Substantive response of the Local Highway Authority to a planning consultation received under The Development Management Order.

Planning Application Number: 23/00944/FUL

Application Address: 20 Brascote Lane Newbold Verdon Leicester Leicestershire LE9 9LF

Proposed dropped kerb and block paving parking space

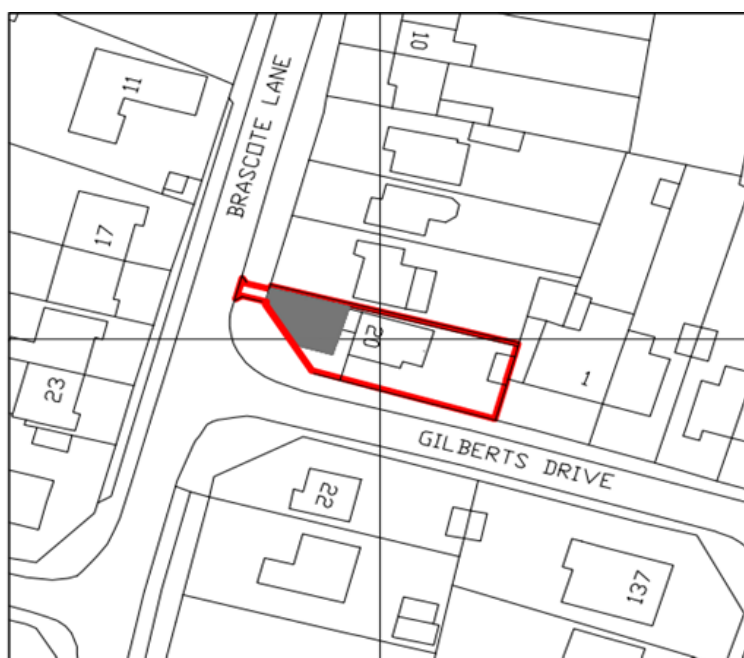
The proposed access is situated on the eastern extent of Brascote Lane. Brascote Lane is an adopted, classified C road subject to a 30mph speed limit. The proposed access is approximately three metres away from the junction of Brascote Lane/Gilberts Drive.

It is noted the dwelling is currently afforded off-street car parking to the rear which is accessed via Gilberts Drive.

Given the proximity of the proposed access with the junction of Brascote Lane/Gilberts Drive, the proposals are contrary to guidance contained within Paragraph 3.31 of Part 3 of the Leicestershire Highway Design Guide (LHDG), which states:

The LHA notes the Applicant's drawing 'Proposed Dropped Kerbs and Block Paving', drawing number 23/007/01 demonstrates a 2m access width, this width is therefore considered substandard. Table DG17 of Part 3 of the LHDG which requires a minimum effective width of 2.75m for a single dwelling private access, add 0.5m if bounded by a wall on one side, 1m if bounded on both sides. Given this, to provide an LHDG compliant access in terms of width, the access would have to be extended south bringing it closer to the junction, this would not be supported by the LHA. This would be further complicated by the requirement for 1m by 1m pedestrian visibility splays within the Applicant's land as per Figure DG17 of Part 3 of the LHDG to ensure a safe and suitable access can be delivered (illustrated within drawing below).

The LHA also have concerns that if approaching the site from the north along Brascote Lane, vehicles travelling behind may be expecting vehicles to turn east onto Gilberts Drive rather than accessing the site. As such, if vehicles accessing the site slow suddenly within the carriageway, this may lead to rear end shunts.

Vehicles egressing Gilberts Drive turning to the north along Brascote Lane may also be presented with vehicles reversing via the proposed access, providing a further possible conflict point within the carriageway.

As previously stated, should the LPA be minded to grant the proposals, the access width should be considered in accordance with Table DG17 of Part 3 of the LHDG which requires a minimum effective width of 2.75m for a single dwelling private access, add 0.5m if bounded by a wall on one side, 1m if bounded on both sides.

The LPA should also consider requesting the Applicant provide detailed, scaled vehicular visibility splay drawings demonstrating visibility splay lengths in accordance with Table DG4 of Part 3 of the LHDG based on the 85th percentile speed of the road. Vehicular visibility splays should be drawn in accordance with Figure DG2a of Part 3 of the LHDG and should be over the Applicants or highway land, and not over third party owned land, to a point 1m into the highway. There should be nothing above 0.6m within the vehicular visibility splays.

Should the LPA be minded to grant the proposals the Applicant should also provide 1m by 1m pedestrian visibility splays within the Applicants land either side of the proposed access. There should be nothing above 0.6m within the pedestrian visibility splays.
